SUBJECT: Safety Recall 04S20: Supplement #1

All 2002 and Certain 2003 Model Year Ford 4-Door Explorer & Mercury Mountaineer

Liftgate Glass Hinge and Ball Stud Bracket (if applicable) Replacement

PURPOSE OF THIS SUPPLEMENT

Q12) If the liftgate glass is broken, requiring an order to be placed for a service replacement glass, will the strut brackets and liftgate hinges on the new glass need to be replaced?

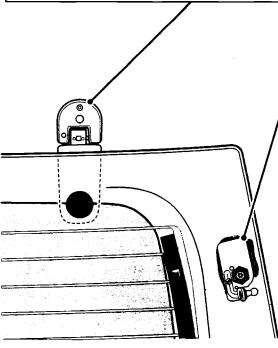
A12) In this situation, please review the illustration below to verify whether the replacement glass already has the latest level hinges, strut brackets and adhesive. This is necessary because your service glass supplier may not have provided the latest level glass assembly. If not, update the hardware and adhesive to the latest level.

THE REPLACEMENT GLASS MUST HAVE:

• The new design hinges. • Large strut brackets. • Hard adhesive.

NEW DESIGN HINGES:

- THICKER PROFILE
- OK TO INSTALL ON VEHICLE.

ORIGINAL DESIGN HINGES:

- THINNER PROFILE
- MUST BE REPLACED PER SAFETY RECALL 04S20.

LARGE BRACKET:

- INSPECT FOR SOFT ADHESIVE BY ATTEMPTING TO LEAVE IMPRESSIONS WITH FINGERNAIL.
- BRACKET MUST BE REPLACED PER SAFETY RECALL 04S20 IF ADHESIVE IS SOFT.
- · BRACKETS OK IF ADHESIVE IS HARD.

CAUTION: ATTEMPTING TO REMOVE A
BRACKET THAT IS ATTACHED
WITH THE NEW
(HARD-TO-THE-TOUCH)
ADHESIVE WILL LIKELY
RESULT IN SHATTERING OF
THE LIFTGATE GLASS.
